2. Response to Comments

This section of the Final Environmental Impact Report (FEIR; Final EIR) for the Harvest Landing Retail Center & Business Park Project (proposed Project) includes a copy of all comment letters that were submitted during the public review period for the Draft Environmental Impact Report (Draft EIR), along with responses to comments in accordance with California Environmental Quality Act (CEQA) Guidelines Section 15088. The 45-day review period for the Draft EIR began on May 30, 2025, and ended on July 14, 2025. A total of 21 comment letters were received in response to the Draft EIR during the 45-day public review period, and one comment letter was received after the close of the public review period.

Figure 1: Snapshot from Appendix C

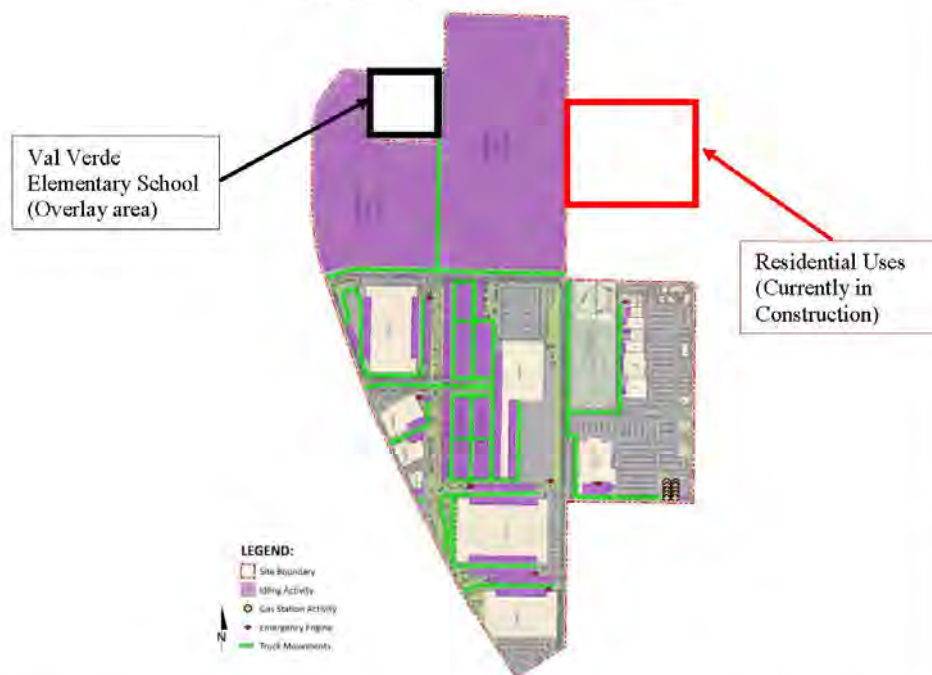
Appendix C – Health Risk Assessment presents on-site truck circulation patterns under both With Overlay and Without Overlay scenarios.³² Under existing conditions, the Overlay area is occupied by Val Verde Elementary School, which is considered a sensitive receptor. Under the Without Overlay scenario, truck circulation routes are shown to pass directly adjacent to the school (see annotated Figure 1). Additionally, areas highlighted in purple indicate zones of truck idling activity, which are concentrated around the school’s perimeter.

Comment A4.9: This comment states that under the Without Overlay scenario, truck circulation routes are shown to pass directly adjacent to the school and areas of truck idling are concentrated around the school's perimeter. The comment states that the Lead Agency is recommended to restrict truck activities from areas adjacent to Val Verde Elementary School and residential uses. The comment states that the HRA appropriately characterizes the truck movements as a conservative scenario for modeling purposes, but the Lead Agency should identify alternative onsite truck circulation routes that would avoid sensitive receptors.

Response A4.9: As disclosed by the commenter, the HRA appropriately provides an analysis of potential diesel particulate matter emissions associated with truck movements in the Phase 2 area as future site plans for development within Phase 2 are unknown. However, the City of Perris will be conditioning the Project to solely provide truck driveways on Orange Avenue in order to avoid the sensitive receptors located along Indian Avenue and Barrett Avenue. In addition, as required by the Harvest Landing Specific Plan and City's Good Neighbor Guidelines, internal circulation routes and loading docks would be oriented away from sensitive receptors, where possible, and truck courts would be required to be screened from offsite view. In addition, as required by Mitigation Measure AQ-20, future industrial developments within Phase 2 would either be required to use zero emission trucks or prepare a site-specific Health Risk Assessment to show that health risks related to onsite diesel particulate emissions would be less than South Coast AQMD significance thresholds. All future industrial or warehouse developments in Phase 2 would be subject to the requirements set forth in the City's Good Neighbor Guidelines, which would further reduce impacts related to trucks on Val Verde Elementary School and the residential development on Barrett Avenue.

Figure 5: MATES Cancer Risk Analysis Of Project Location

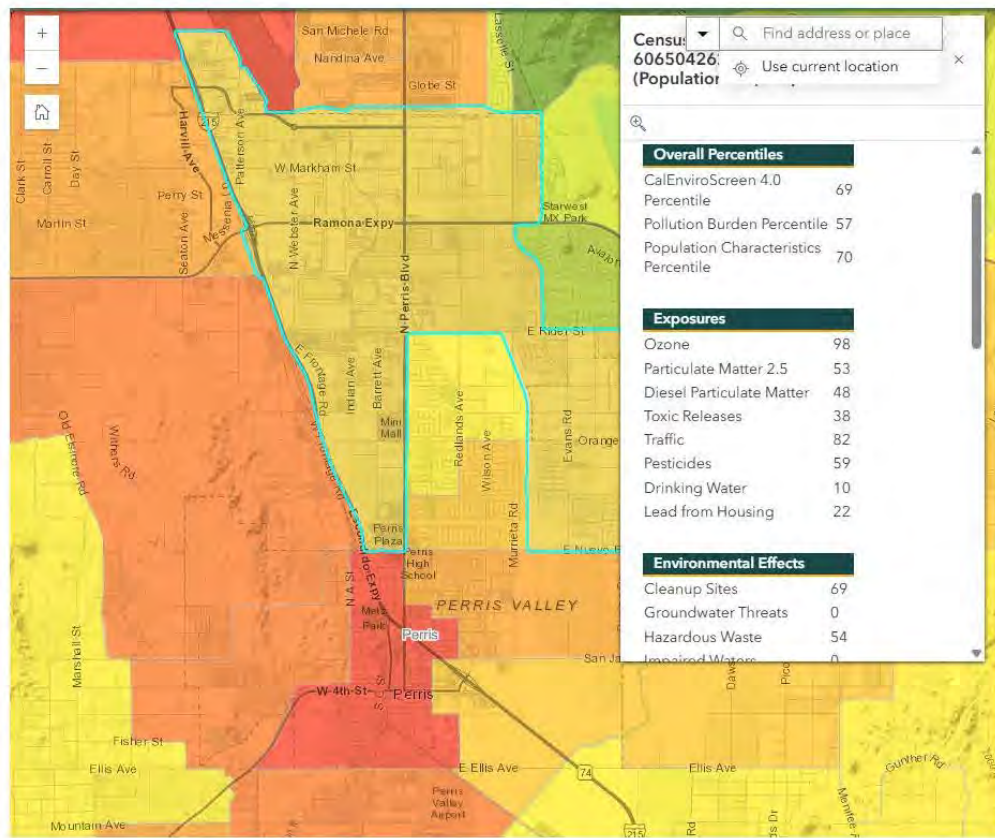
For cumulative impacts, SCAQMD has initiated a public process to update existing guidance due to community concerns about high-risk health impacts from air toxics, particularly from aggregation of warehouses. Since 2022, SCAQMD has held six Working Group (WG) meetings to develop additional guidance for analyzing such potential impacts.²¹ The first two WG meetings focused on Information Gathering and Analysis as well as the Initial Objective and Scope of the WGs. The third WG meeting was specific to the Initial Objective and Scope of the WGs and pushed into the Conceptual/Potential Cumulative Health Risk Assessment protocols. WG meetings #4 and #5 focused only on the Conceptual/Potential Cumulative Health Risk Assessment protocols. WG meeting #6 (WG 6), held in November of 2024, refined the proposed the Conceptual/Potential Cumulative Health Risk Assessment protocols based on public comments. The result of WG 6 was a draft process/analysis flow diagram which is intended to be used to inform the drafting of a planned Draft Guidance Document for conducting Cumulative Health Risk Assessments in the South Coast Air Basin.

Step 1 of the WG 6 process for determining the cumulative significance threshold is to identify the background cancer risk affecting the Project area via the SCAQMD Multiple Air Toxics Exposure Study (MATES).²² According to SCAQMD's MATES V study, zip code 92571 (the location of the Project Site) has a cumulative cancer risk of 308 in 1 million placing it in the top 15% of communities in the South Coast Air Basin (SCAB) impacted by TACs. More than 68% of that risk is from exposure to DPM.

Figure 1: Demonstration of the Effectiveness of Noise Barriers for Residences along Bartlett Ave

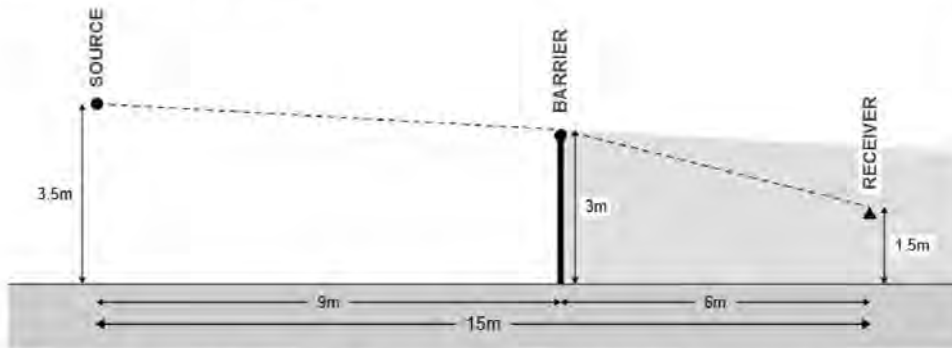
Finally, the assertion of sound walls not providing a break in line of sight is not accurate. First floor receivers are typically assumed to be 1.5 meters tall. If noise barriers were built along the western edge of Bartlett Road, trucks in the northbound lane would be 9 meters from the wall, and the wall would be 6 meters from the edge of first row buildings. If the truck exhaust is assumed at 3.5 meters, any noise barrier 3 meters (roughly 10 feet) tall would block line of sight, as seen in the diagram below. This is before accounting for wheel-pavement noise having complete line of sight blocked. First-floor receivers would receive benefits from potential mitigation. A 5 dB reduction is cited by the DEIR on page 54 of Appendix Q, as "simple to attain when blocking the line-of-sight from the noise source to the receiver" and thus would reduce the 5.8 dB increase shown in Table 5.12-15 in the DEIR to below significance thresholds.
